APPENDIX C CODE CHANGE PROPOSAL NORTH CAROLINA BUILDING CODE COUNCIL

North Carolina State Building Code, Volume Electrical - Section All

Proposed North Carolina Amendments to 2023 NEC
Prepared by Electrical Adhoc Committee – April 28, 2023

Figure 410.2 Exception Clothes Closet Storage Space Exception

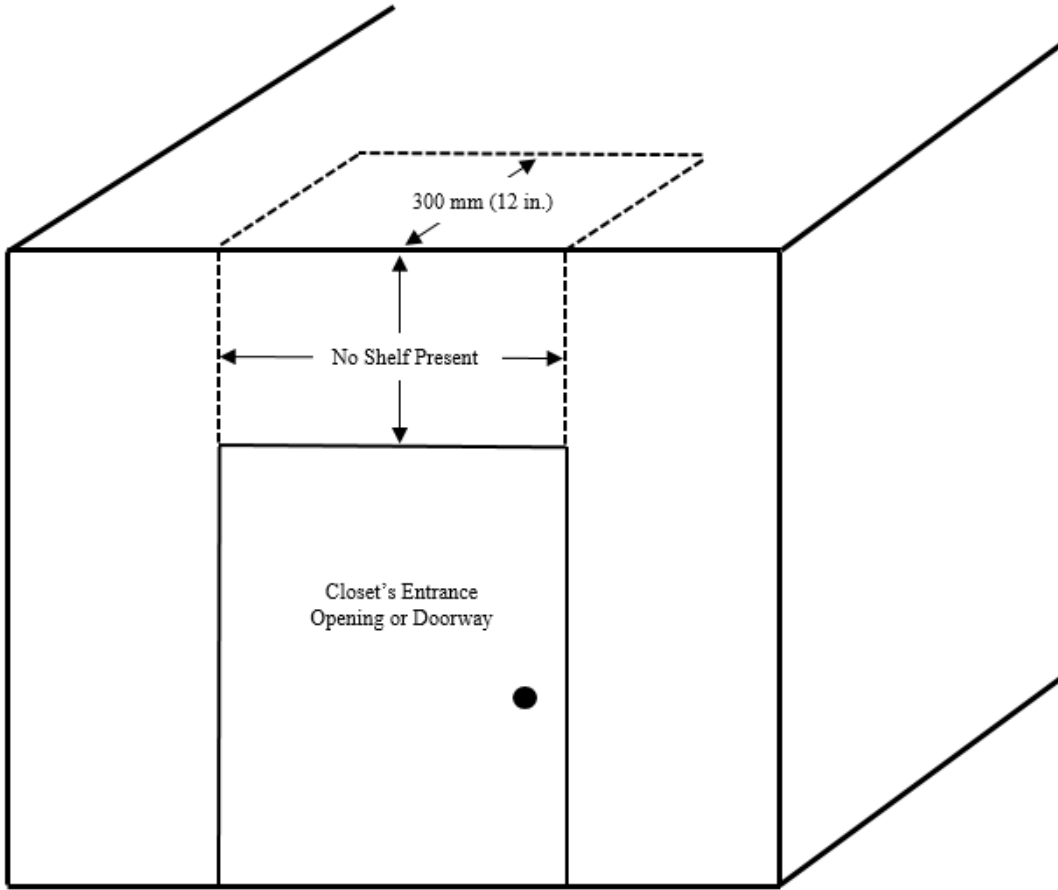
Exception: Where a shelf is not present in the area of wall above the closet's entrance opening or doorway extending from the top of such opening or doorway vertically to the ceiling, including the area of ceiling extending perpendicular from the area of wall directly above the closet's entrance opening or doorway to a horizontal distance of 300 mm (12 in.), shall not be defined as closet storage space. See Figure 410.2 Exception.
